# FCC CLASS II PERMISSIVE CHANGE REQUEST LETTER

**RE: FCC Permissive II Change Request for Company:** Ningbo Lingzhu Technology CO., Ltd.  
**FCC ID:** 2A789SC009

We are submitting an application for a class II permissive change to the FCC approval of the Company name: Ningbo Lingzhu Technology CO., Ltd., product description: Smart Camera (FCC: 2A789SC009 , Original Grant Date: 08/31/2022). The transmitter module itself has not changed. Here are the changes:

Please see the following internal photos to show the differences  
SC009-WL2:

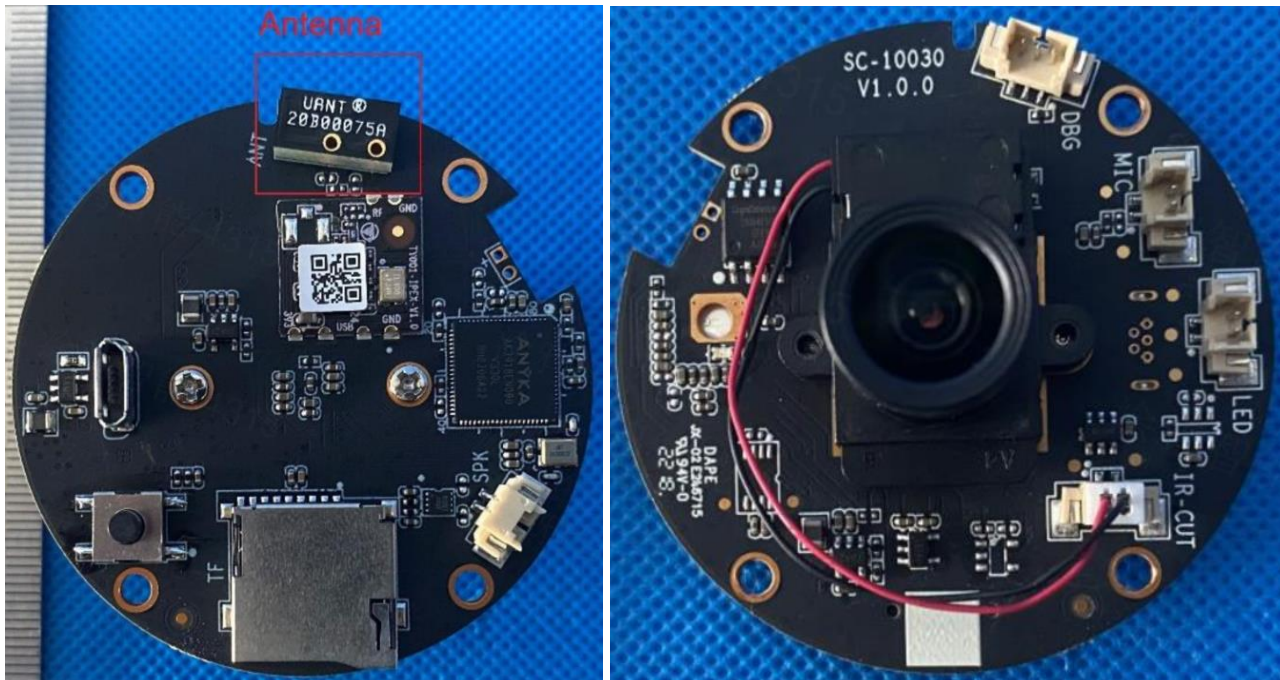
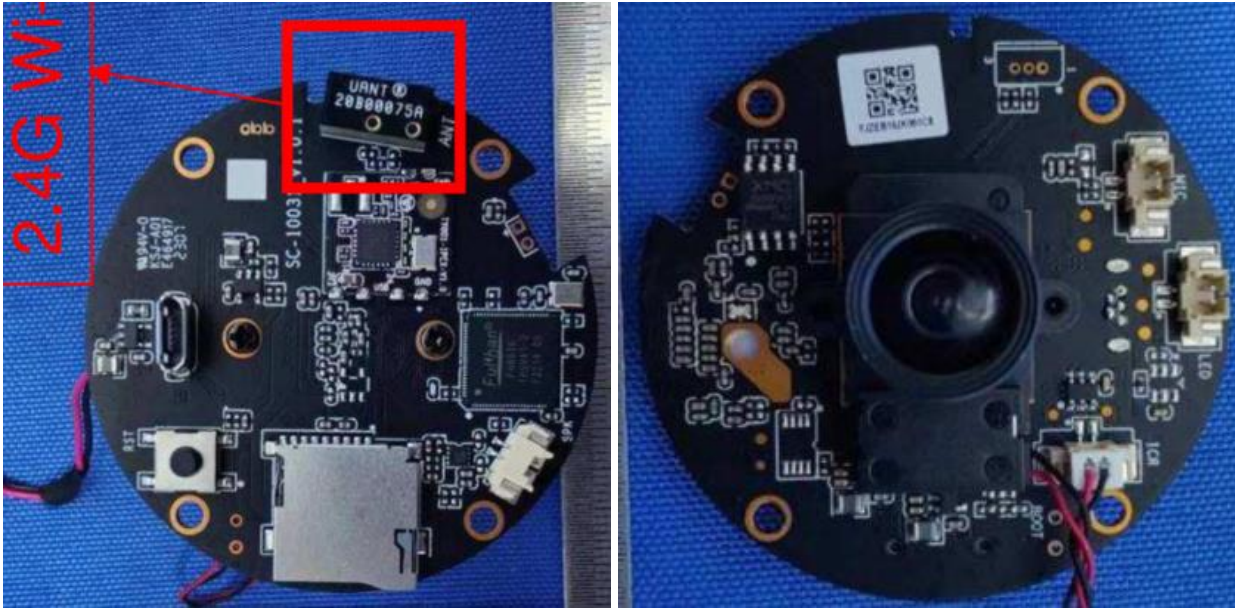
- 1、 The Wi-Fi module and Wi-Fi antenna are same, the radio parameters have not changed.
- 2、 The differences between models are that model name, bracket, the main board soc and the matching resistors and capacitors that support the soc work.
- 3、 Since the main board soc are different, the matching resistors and capacitors that support the soc work are different, the layout has also been changed accordingly to make the product work stable.
